Rezoning Transportation Analysis

Petition Number: 2019-153

Date	Description
11-20-19	First Review

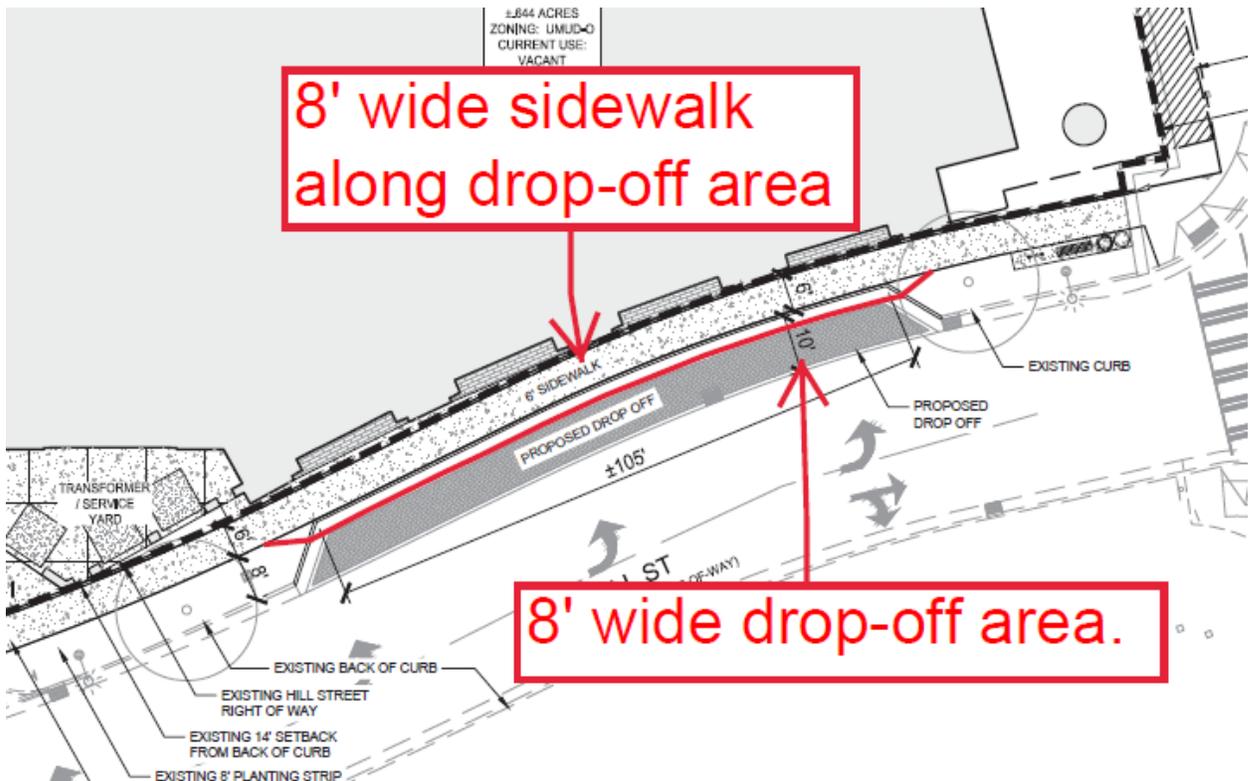
1. **Curblines** The proposed zoning district has a setback measured from back of the existing or proposed future curblines.
 - a. **South Tryon Street:** The future location of curb and gutter is in its existing location.
 - b. **Hill Street:** The future location of curb and gutter is in its existing location.

The site plan should show the curb and gutter labeled and dimensioned from the centerline for each road.

2. **Traffic Study** A Traffic Impact Study is not necessary for the complete review of this petition. If during the permitting process the site generates more than 2500 daily trips, then a traffic study will be required.
3. The petitioner should revise the site plan and conditional note(s) to show an 8-foot-wide drop-off area instead of 10 feet and 8-foot-wide sidewalk along the drop-off area as shown below. This will provide more capacity for pedestrians, valet personal, and patrons accessing their vehicles.

4. The petitioner should revise the site plan and conditional notes to state the valet/drop-off zone will be ADA accessible and meet ADA requirements.
5. **Resolved** ~~Sample format for comment that is resolved~~
